2	&	4
B0300050

SB, 357 XP, 359, Metric screws, 2003-11

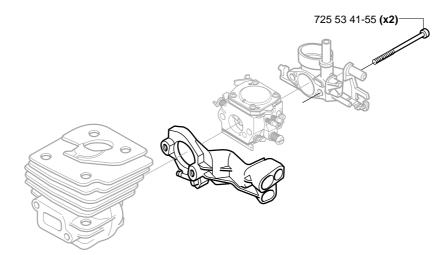
The screws that fasten the carburettor to the cylinder have been replaced to improve the strength of the screw joint reinforcement. Metric screws replace the self-tapping (PL) screws. New and old parts are fully interchangeable.

357XP 034200401 359 034200901

New part no. 725 53 41-55

Description Screw MC6S Excl. part no.
